UNITED STATES PATENT AND TRADEMARK OFFICE

APPLICATION NO.	FILING DATE	FIRST NAMED INVENTOR	ATTORNEY DOCKET NO.	CONFIRMATION NO.				
10/590,139	02/11/2008	Neil Duggal	HO-P03203US0	5647				
44270 IMDS, INC. 124 SOUTH 600 WEST LOGAN, UT 84321	7590 01/21/2011		<table border="1"><tr><td>EXAMINER</td></tr><tr><td>SNOW, BRUCE EDWARD</td></tr></table>		EXAMINER	SNOW, BRUCE EDWARD		
EXAMINER								
SNOW, BRUCE EDWARD								
			<table border="1"><tr><td>ART UNIT</td><td>PAPER NUMBER</td></tr><tr><td>3738</td><td></td></tr></table>	ART UNIT	PAPER NUMBER	3738		
ART UNIT	PAPER NUMBER							
3738								
			<table border="1"><tr><td>NOTIFICATION DATE</td><td>DELIVERY MODE</td></tr><tr><td>01/21/2011</td><td>ELECTRONIC</td></tr></table>	NOTIFICATION DATE	DELIVERY MODE	01/21/2011	ELECTRONIC	
NOTIFICATION DATE	DELIVERY MODE							
01/21/2011	ELECTRONIC

Office Action Summary

DETAILED ACTION

FIG. 25

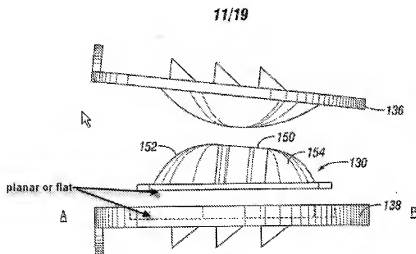
Applicant's amendments to claims 32, 41, 51, and 58, describing the articulating surfaces of the nucleus and bottom plate are planar or flat, as shown in the drawing, overcame the anticipation rejections of Zucherman et al (7,320,707) and Marik et al (2005/0216086).
